GTC Member Proposed Amendments to the Girdwood Trails Master Plan Jan 18 2022.  
Proposed changes may not be addressed in the order shown.

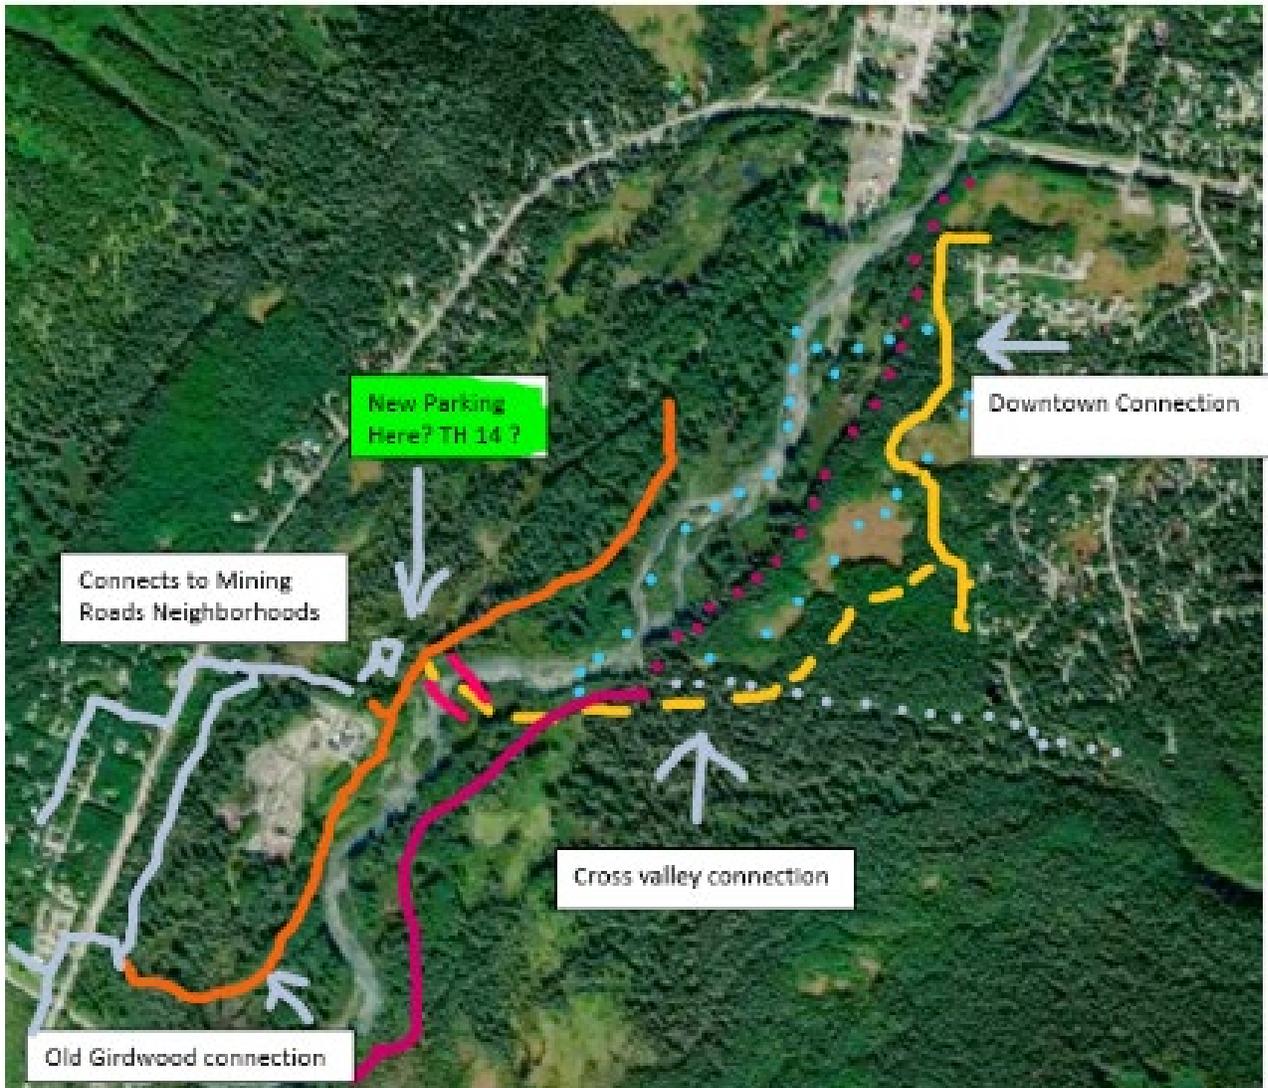
Proposed Motion: Add to the draft plan a new class 3 trail traversing parcel 6-036 and other nearby lands generally following the route that is indicated on the attached map.

Proposed Motion: Add to the draft plan a new site to locate bridge 1. Remove from the draft plan the old location of bridge 1. Select the new location of bridge 1 to correspond with the southern termination of the trail described in motion 1. (eg Amendment 11)

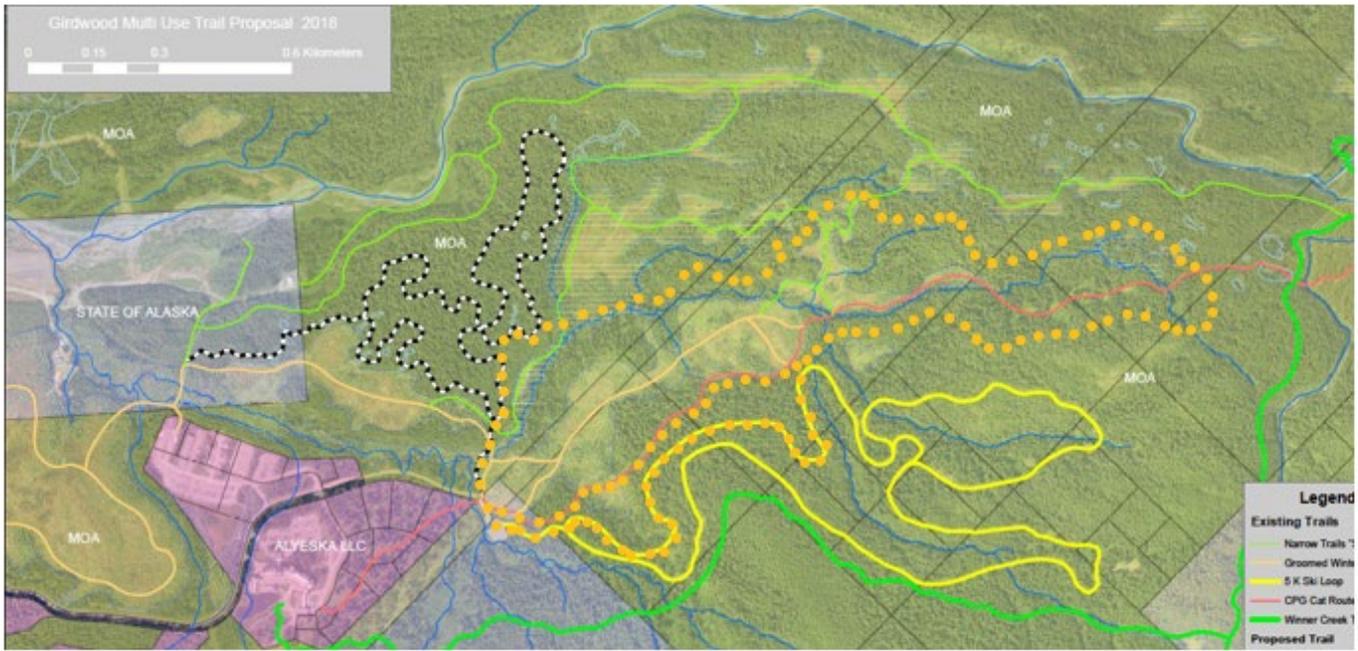
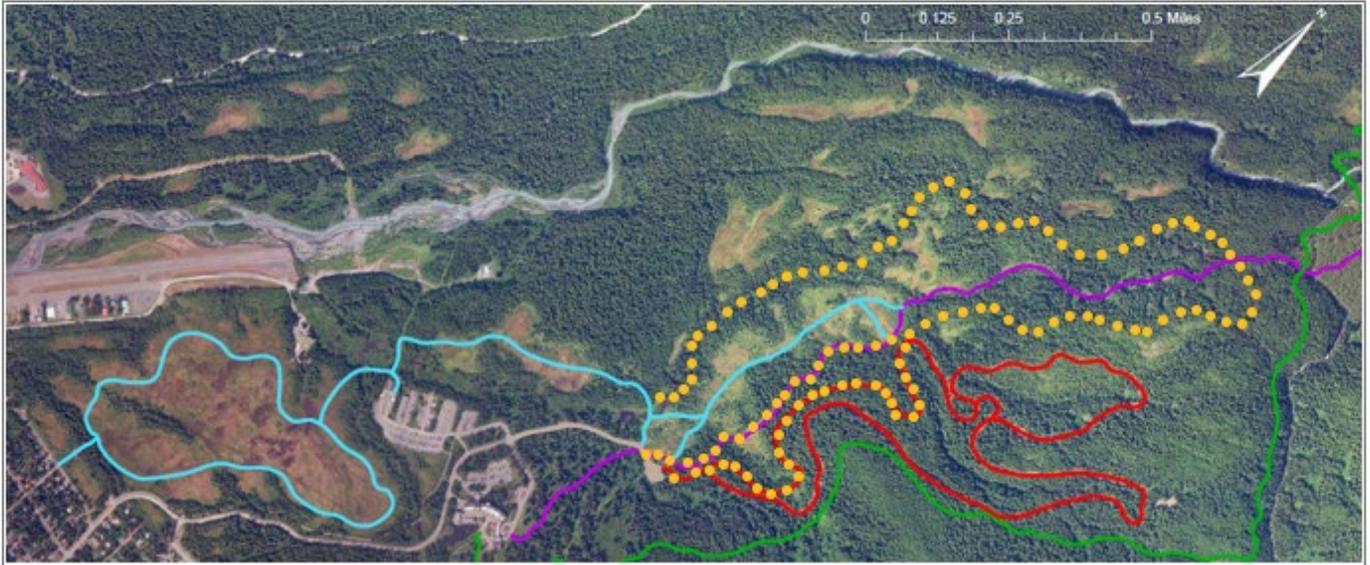
Proposed Motion: add back an Upper Valley Connector from the Forest Loop to the CPG CAT Track near the CAT Track Bridge. (see maps below)

While the exact area of the connector trail can be discussed in the future, showing a Class 4 year-round looped trail system is congruent with the community survey results and Girdwood Master Plan comments. The trail originally included in the plan was removed because people commented the space was crowded. Yet, if you look at the summer map the GTC created (shown below), no summer trails exist in this area. This area has been repeatedly zoned and defined as Open Space and Recreation Zone. In 2006, HLB commissioned a trail feasibility study to determine where to add 20 Kilometers of multi-use trails to this area. I agree that the primitive trails should remain primitive, but I disagree with this proposed primitive area covering all of the uplands of the Girdwood valley west of the CAT track, thus prohibiting a future multi-use trail system development that includes summer or winter bike travel.

### **PT1 Expansion to Wagon Trail**

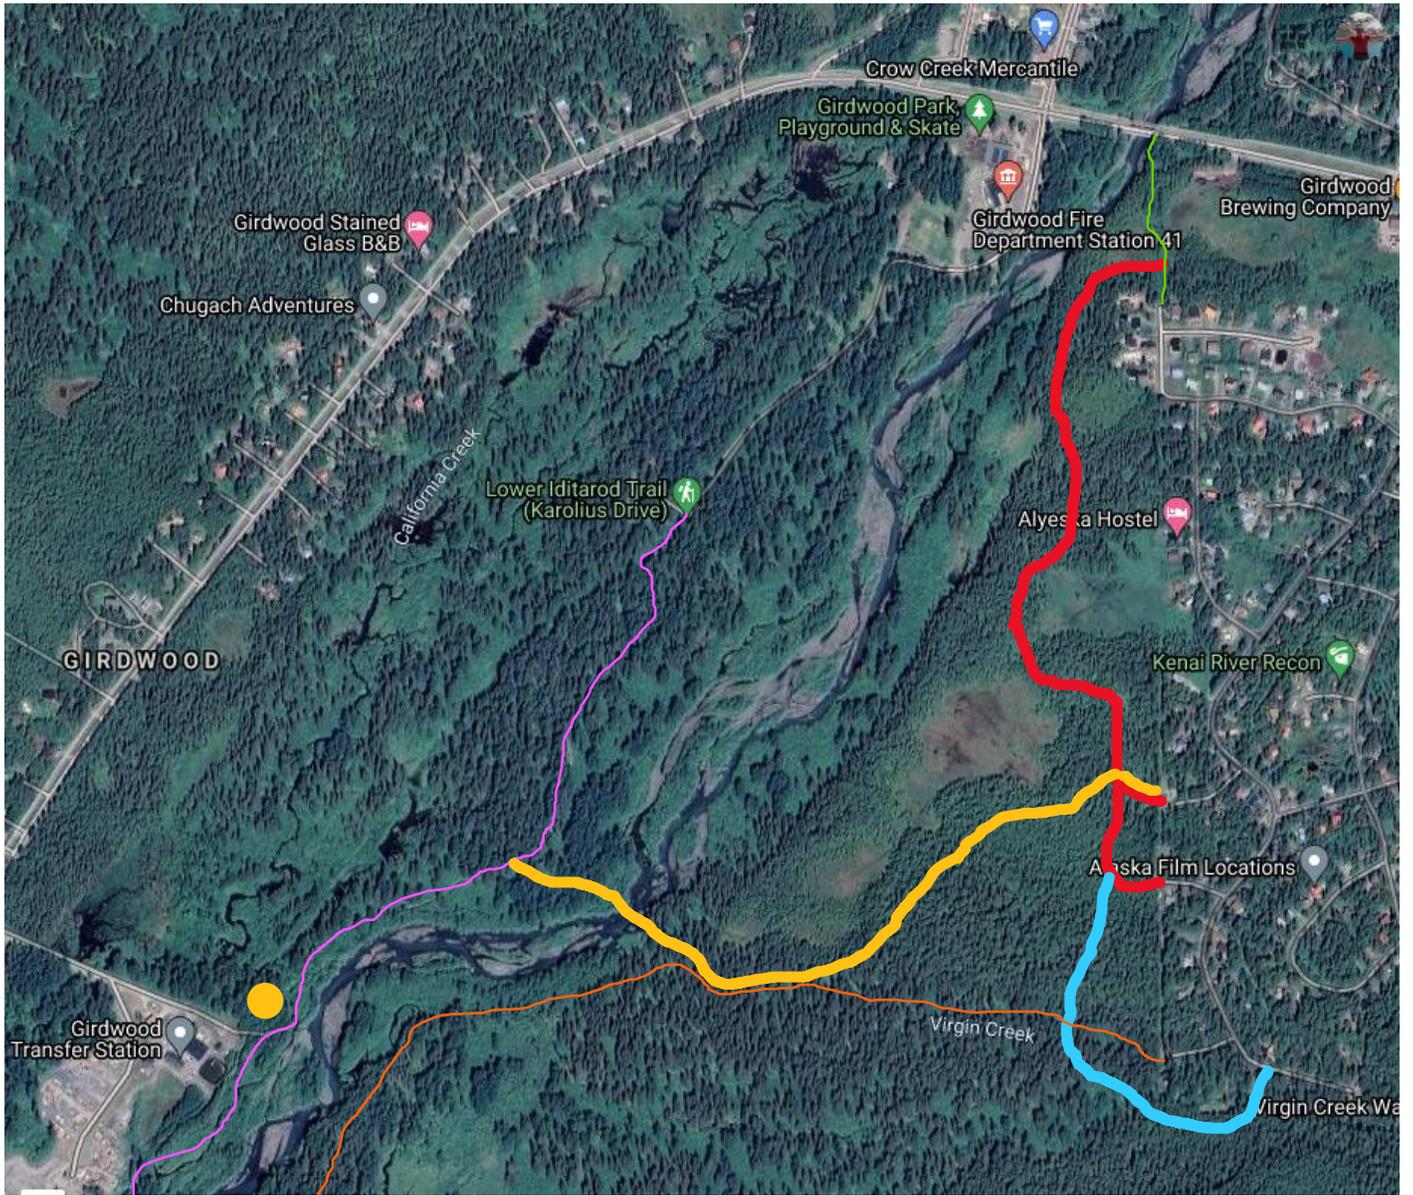
Expand PT1 east to include Wagon Trail.

Recommend adjusting the boundary of NS1. The eastern boundary should extend and include Wagon Trail.

- Wagon Trail is a Class 1 trail and would be a good landmark to delineate the eastern boundary of PT1.
